## Planning and Assessment

### Gateway determination report

<b>LGA</b>	Ku-ring-gai
<b>PPA</b>	Ku-ring-gai Council
<b>NAME</b>	Lindfield Village Hub (153 homes, 141+ additional jobs)
<b>NUMBER</b>	PP-2020-866
<b>LEP TO BE AMENDED</b>	Ku-ring-gai Local Environmental Plan (Local Centres) 2012
<b>ADDRESS</b>	1 Woodford Lane, Lindfield 2, 4, 6, 8 10, 12 (part), Bent Street, Lindfield 1B Beaconsfield Parade, Lindfield 19 Drovers Way, Lindfield Drovers Way Road Reserve Woodford Lane Reserve
<b>DESCRIPTION</b>	Lot A DP 445535, Lot 9 DP 1090427, Lot 10 DP 3498, Lot 3 DP 667420, Lot 1 DP 724823, Lot 4 DP 1226294 & Lot 8 DP 1226294, Lot 7 DP 1226294 , Lot 2 DP 1226294 & Lot 5 DP 1226294, Lots 1-15 DP 1099330 & Lot 1 DP 1226294, Lot 6 DP 1226294
<b>RECEIVED</b>	31/07/2020
<b>FILE NO.</b>	IRF20/4631
<b>POLITICAL DONATIONS</b>	There are no donations or gifts to disclose and a political donation disclosure is not required
<b>LOBBYIST CODE OF CONDUCT</b>	There have been no meetings or communications with registered lobbyists with respect to this proposal. A meeting was held with the Support Lindfield Group (as detailed in section 1.6).

Figure 13: Elevations looking north-west showing the interaction between the proposed towers (shaded pink), existing dwellings (hatched outline) separated by Drovers Way and also indicating the existing height limit controls (red dashed line) (Urban Design Report page 55).

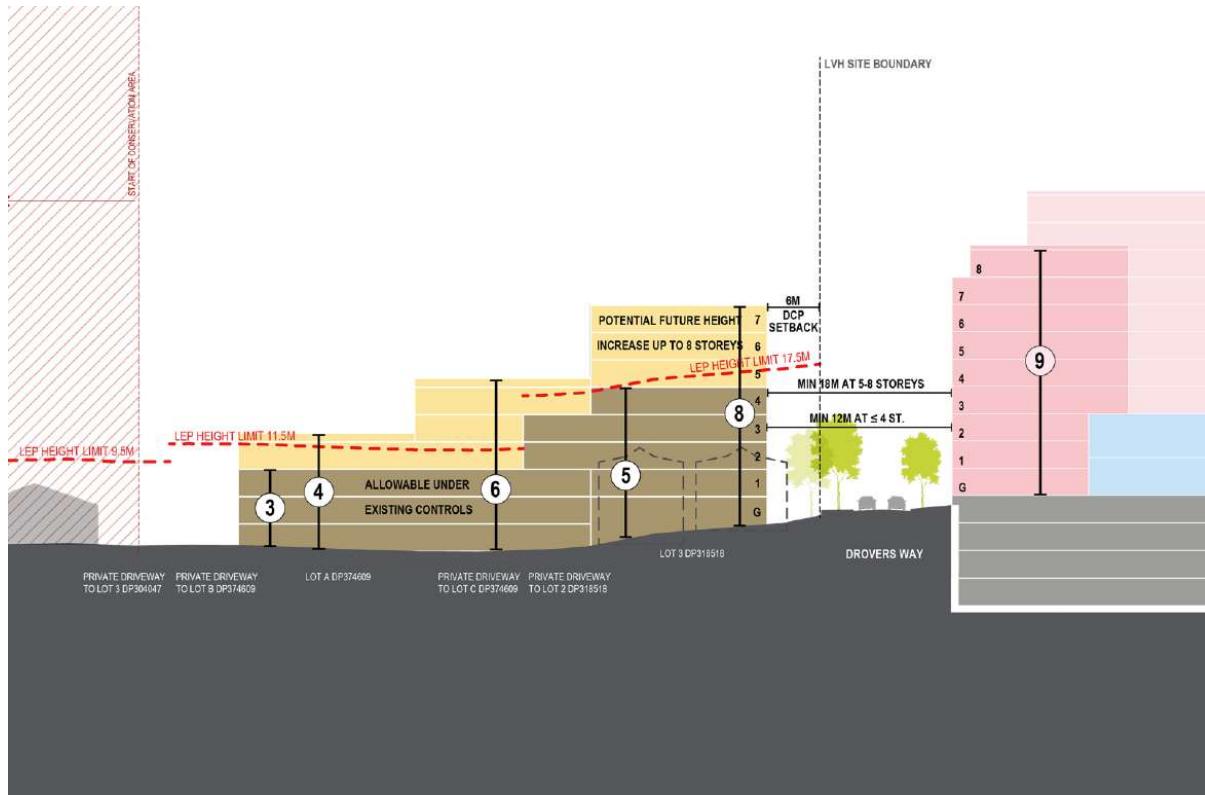
Further consideration of the extent of overshadowing on properties to the west should be undertaken during the development assessment process, noting that the current maximum height of buildings is 17.5m in the R4 High Density Residential Zone immediately west, and that there are several existing single detached dwellings in this area.

In addition, the southern tower along Drovers Way should consider a reduction in height, or increased setback to upper floors. This should alleviate the imposing bulk and scale and the overlooking/overshadowing issues and is a recommended condition of the Gateway determination. It is also recommended that the proposal be forwarded to the Government Architects office during the consultation period, for comments on the preferred design scheme.

- (b) Amend the south west tower reference scheme and planning controls to provide a more sympathetic transition to the surrounding existing lower density residential dwellings. This may include a reduction in building height and/or more appropriate setbacks to address bulk and scale issues for upper levels;

Figure 14: Elevations looking south-east

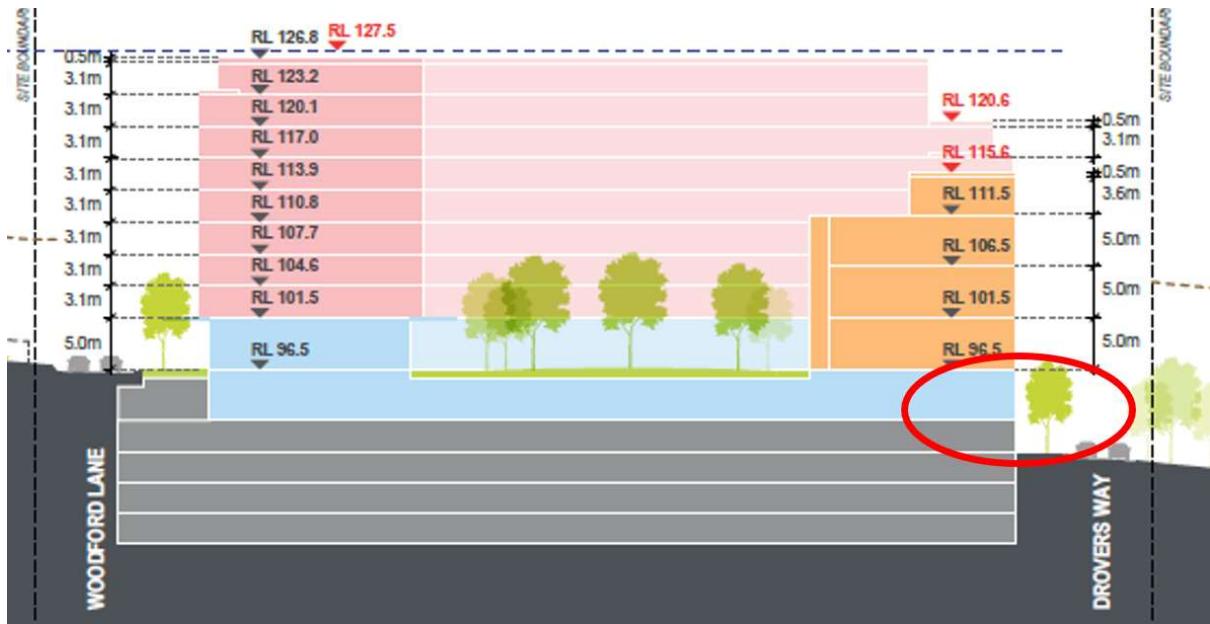
It is noted that the Urban Design Report (**Attachment A**) shows a car parking level above ground level (see **Figure 14** below). Refinement of the design through the development assessment process should seek to reduce the associated impact on amenity through sensitive design and appropriate screening.
